Amendment No. 1

Tender No. HSCC/KCGMC/PACKAGE-II/2013

Project Name - Construction of Hospital, OPD & other Associates Works including dismantling of existing buildings & their foundation for Kalpana Chawla Govt. Medical College (KCGMC), Karnal, Haryana.

Reply of Bidder's queries raised during Pre-bid meeting held on 19.06.2013 at HSCC, Head Office, Noida.

ELEVATION B
ELEVATION D

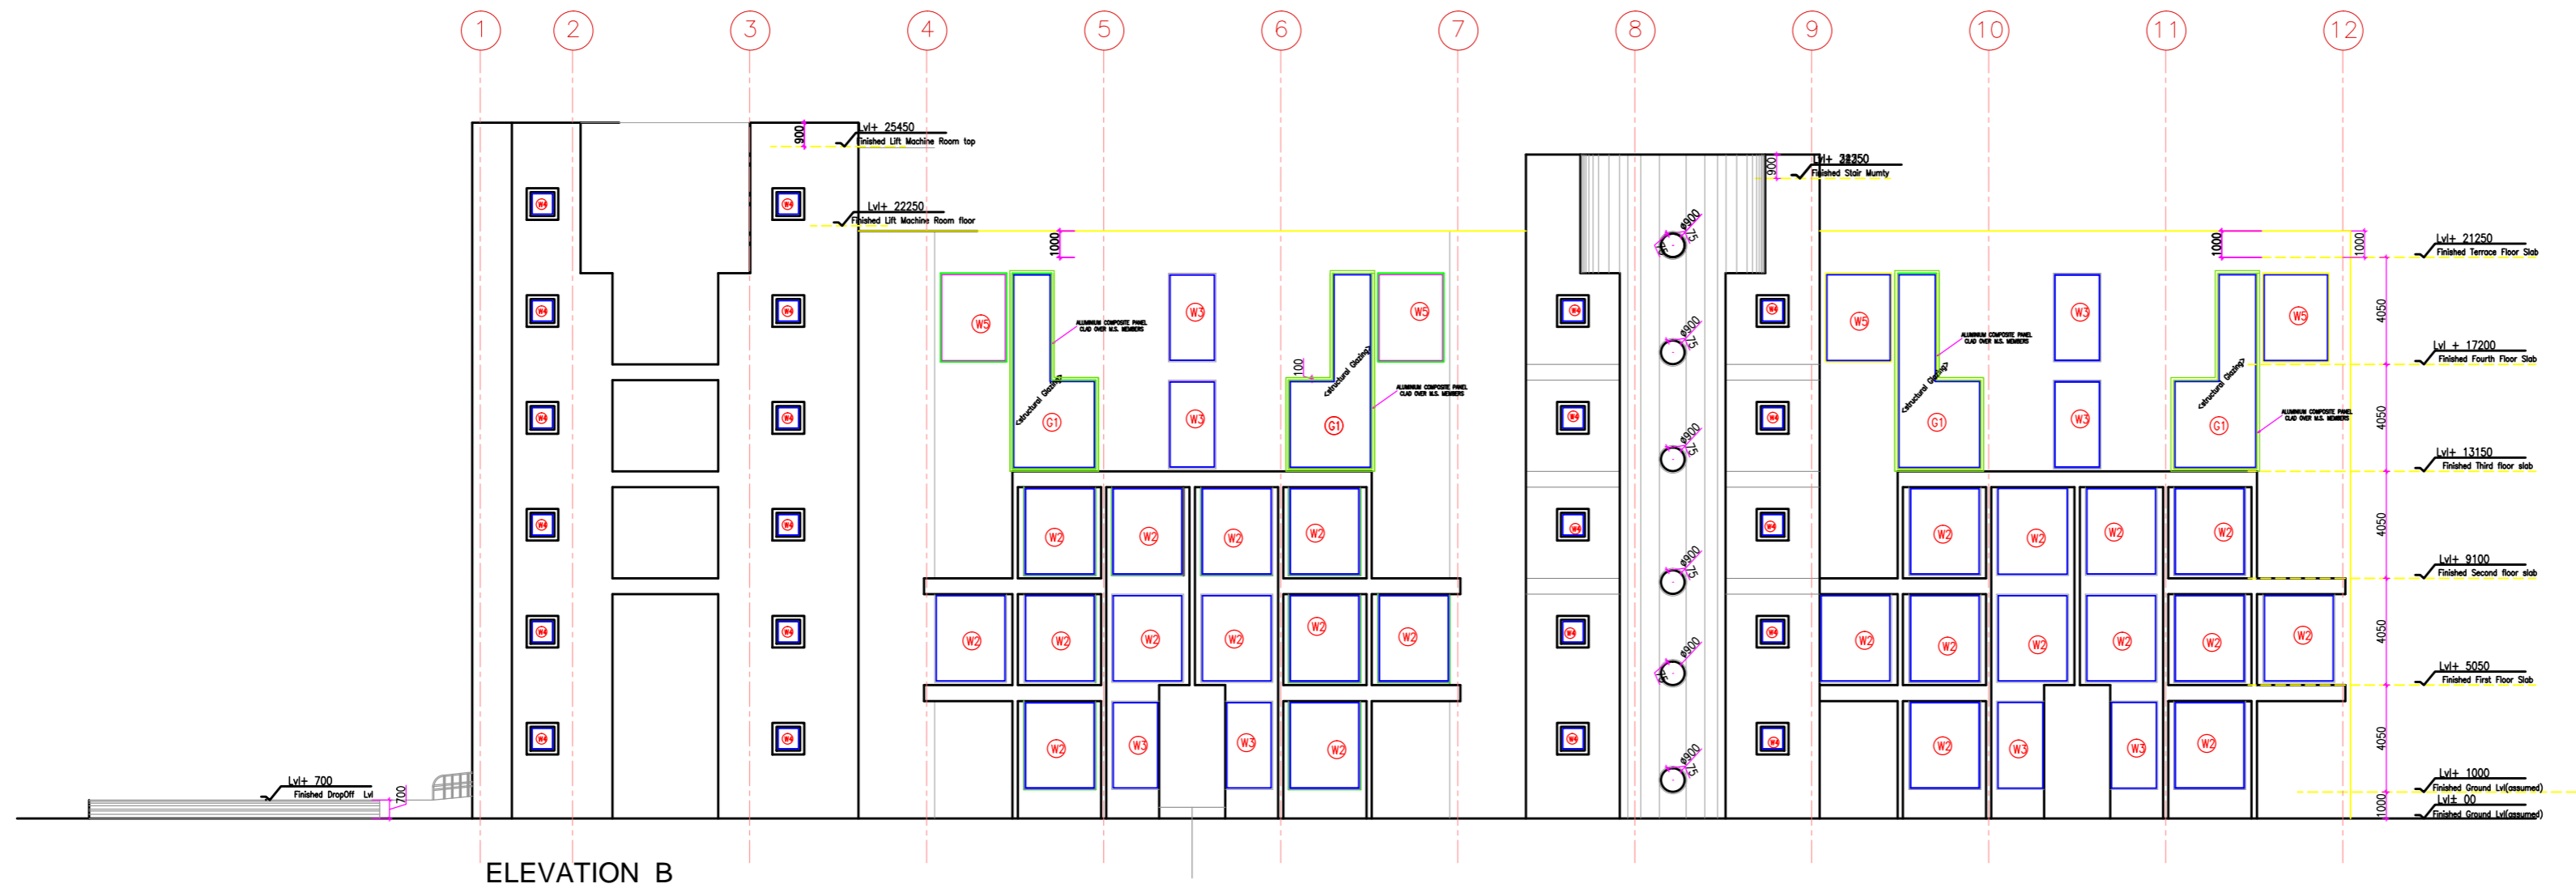
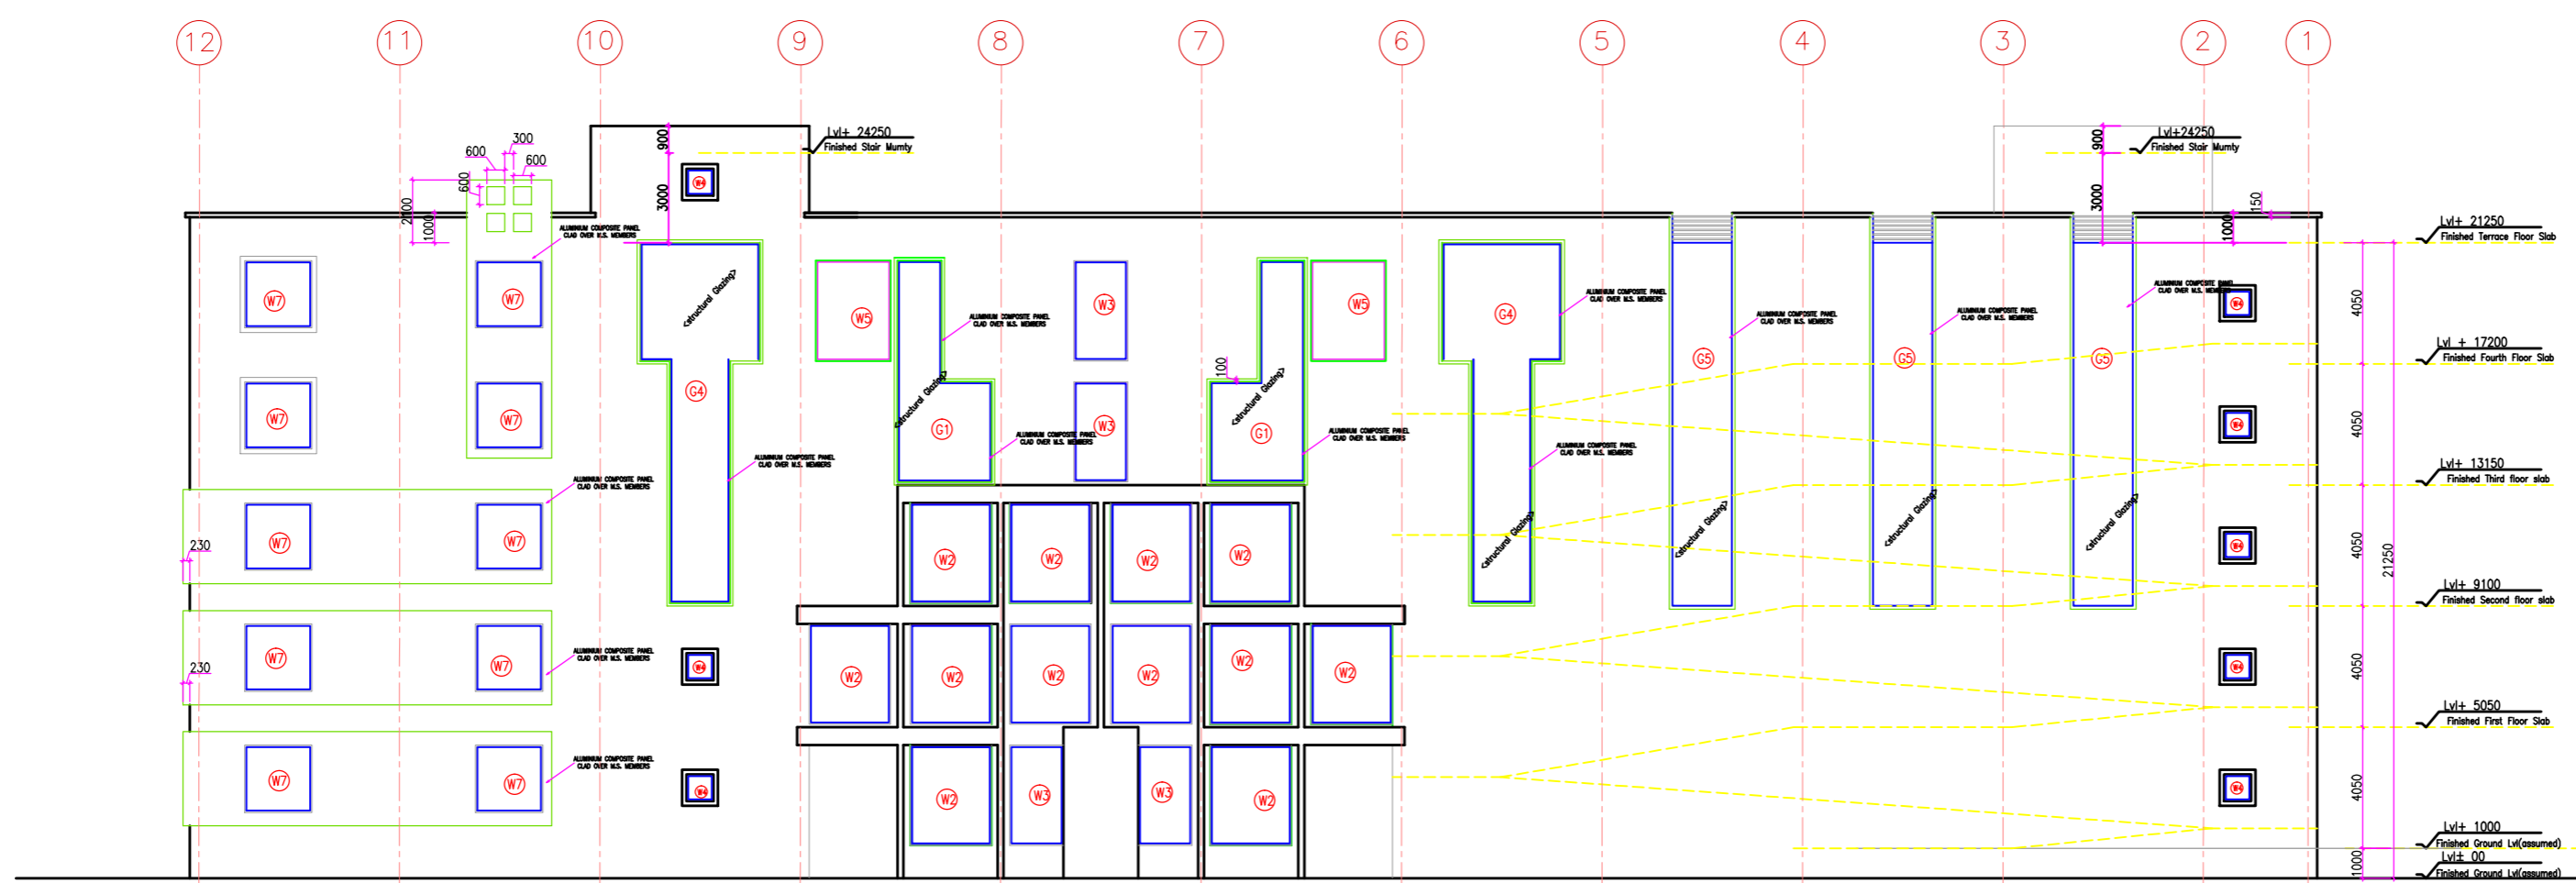
34.	<p>Request to provide Elevation & Cross</p>	Has been uploaded on web site along with

sectional drawings for hospital & OPD Block.	this reply.
35.	Request to provide soft copy of tender drawings to enable us to study it and submit our most competitive & comprehensive bid.	Tender drawings already available at tender web site.
